#2014-58 Crystal Lake South High School Project Review for Planning and Zoning Commission

Meeting Date: April 15, 2015

Requests:

COMMUNITY HIGH SCHOOL DISTRICT 155
SOUTH HIGH SCHOOL - OUTDOOR BLEACHERS / PRESSBOX
1200 SOUTH MCHENRY AVENUE
CRYSTAL LAKE, ILLINOIS 60014
ELEVATIONS/SECTIONS EAST + WEST BLEACHERS

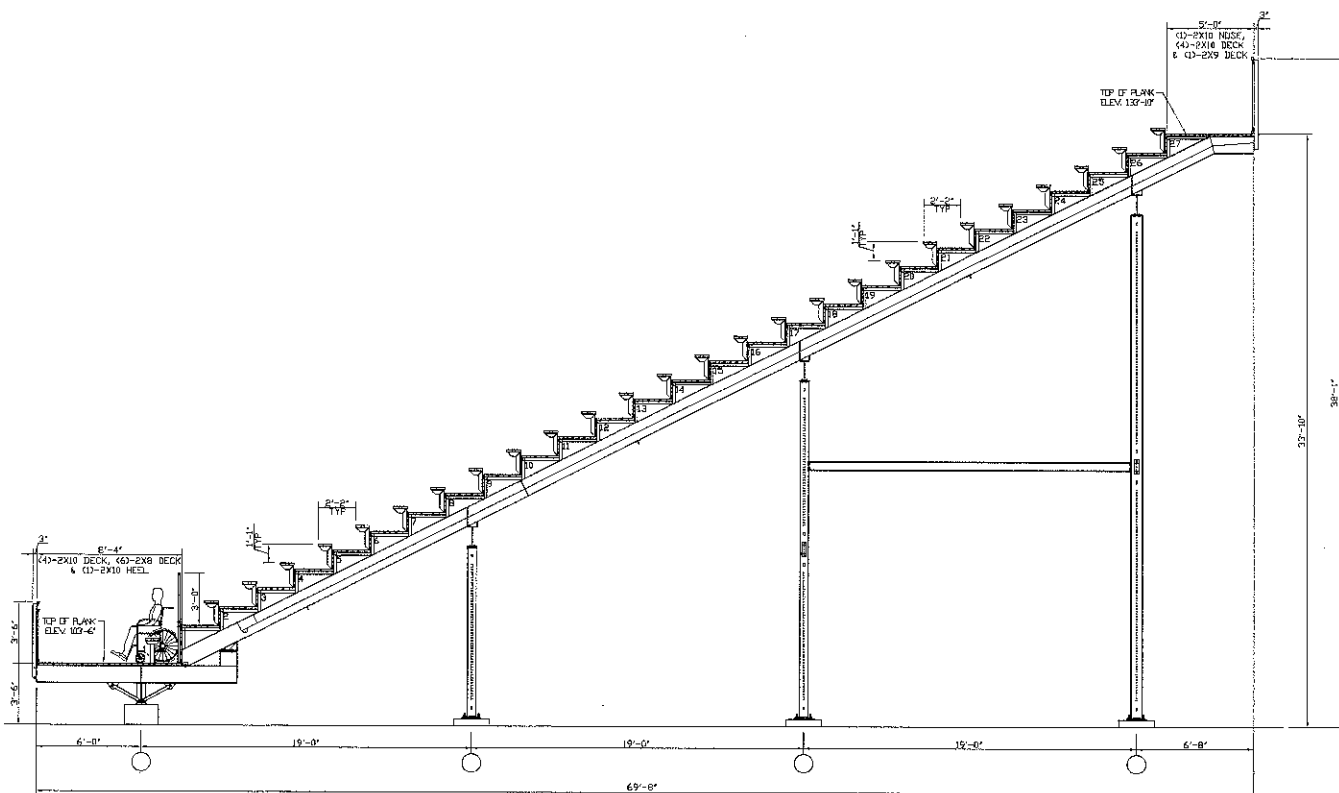
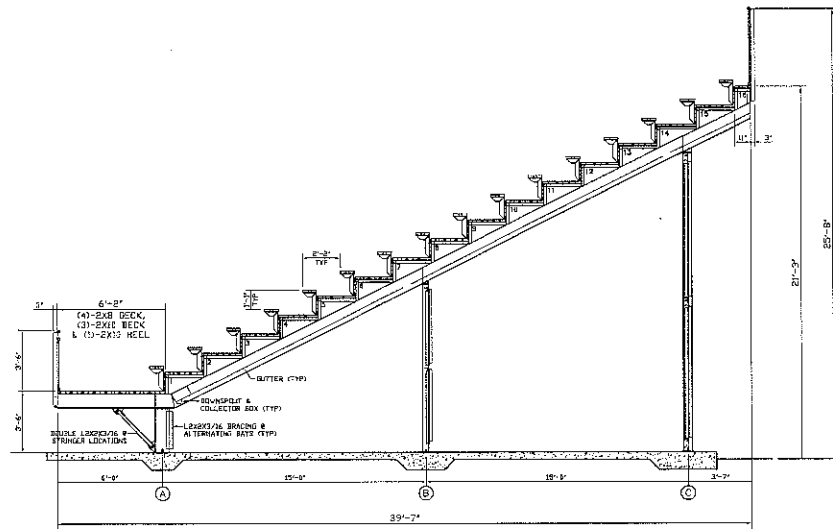
- The plans submitted as part of this petition indicate that the press box incorporated into the Replacement Bleachers would be relocated to the east side bleachers.

- The height of the west side bleachers, after the relocation of the press box, would be 38 feet 1 inch.
- The height of the east side bleachers, after the addition of the press box, would be 31 feet 7 inches.

LANDSCAPE PLAN

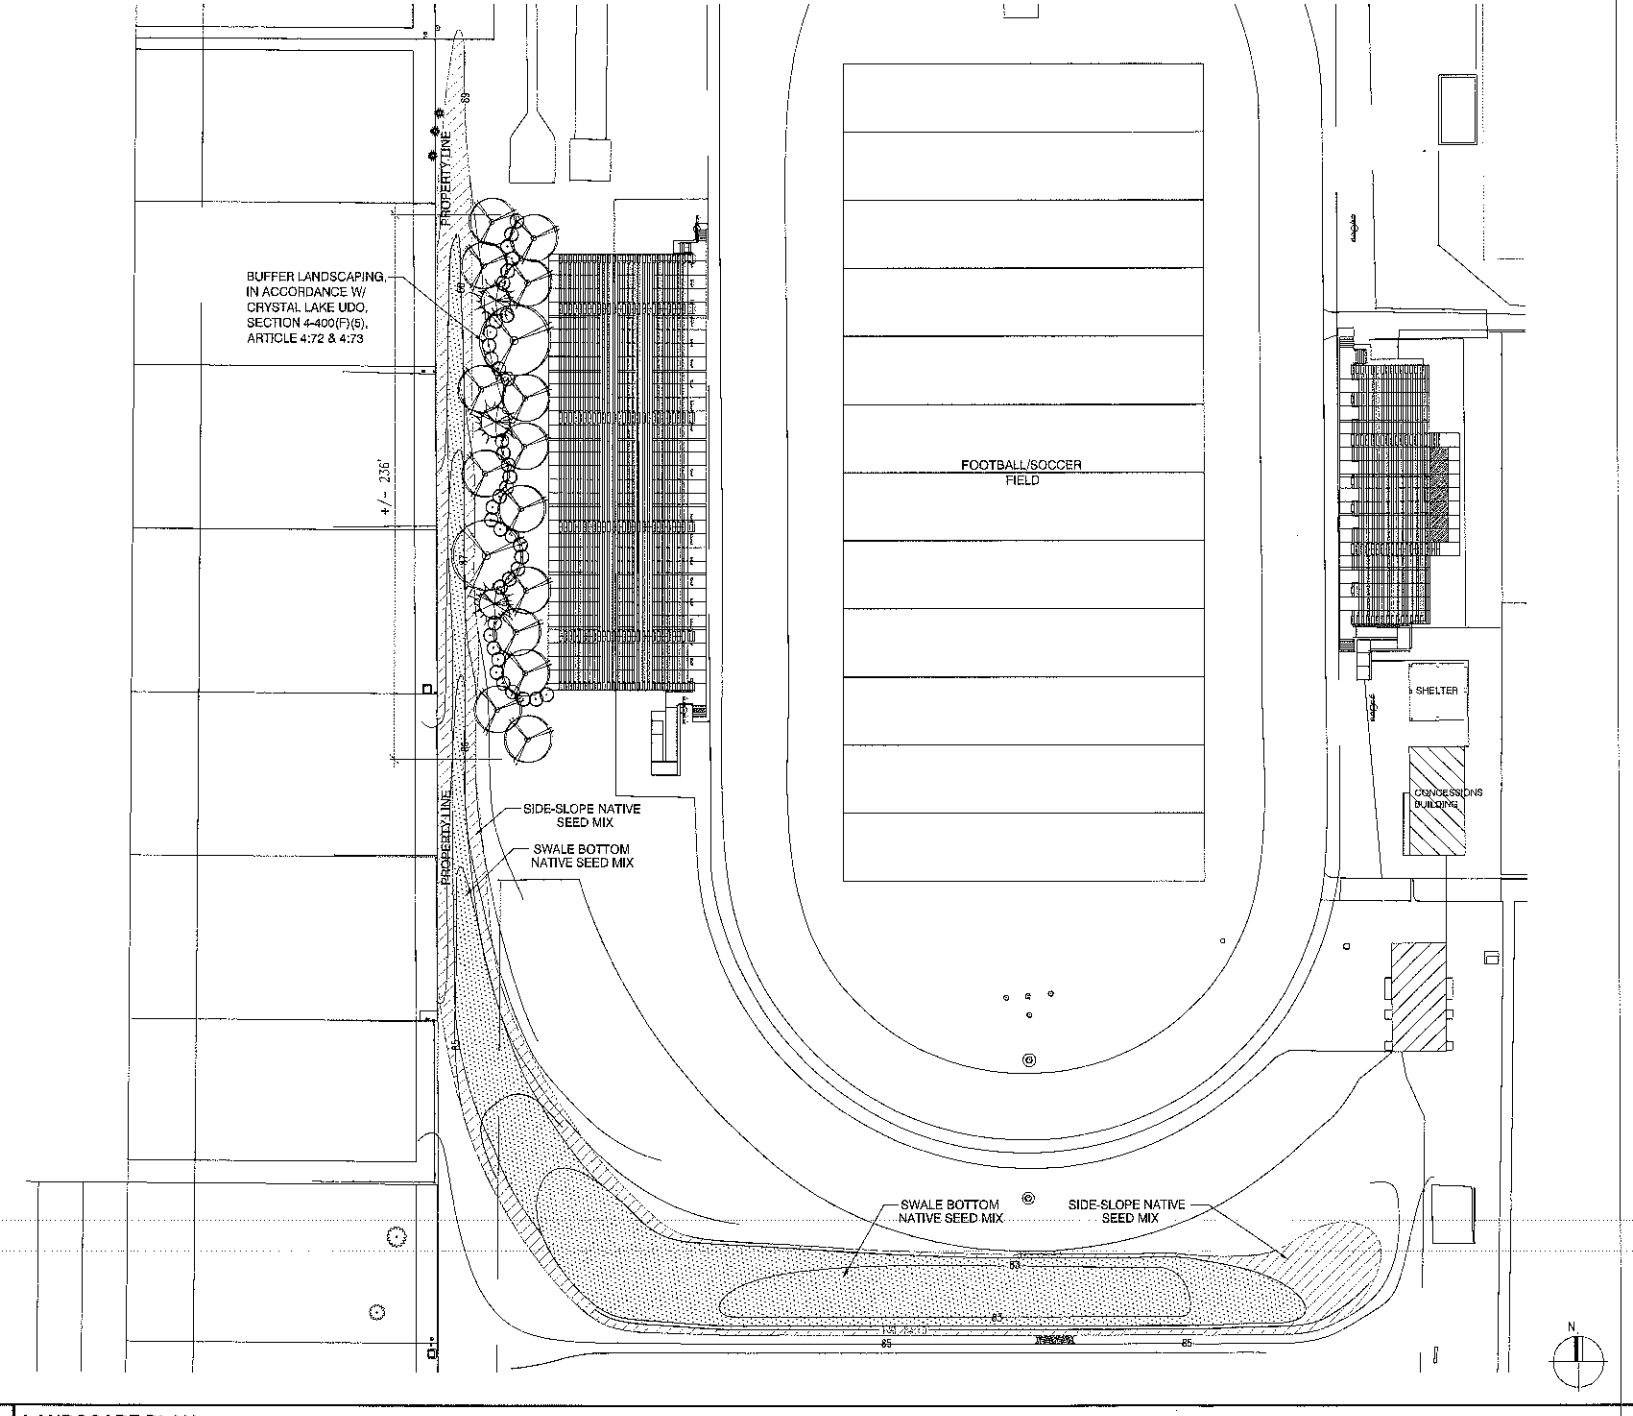
- The submitted landscape plan shows proposed landscaping to provide a 25-foot buffer area between the west side bleachers and the single family residential.
- Given the intensity of the west side bleachers (both the Replacement Bleachers and with the proposed modifications) and their proximity to the existing single family homes, a more solid landscape screen is recommended.

foot tall arborvitae or other acceptable substitution, planted nine feet on center in a double staggered row, to meet the screening requirements of the UDO, must be planted as early in Spring as practical and maintained as long as the bleachers are present. Planting locations should reflect the comments from the City's stormwater consultant, CBBL.
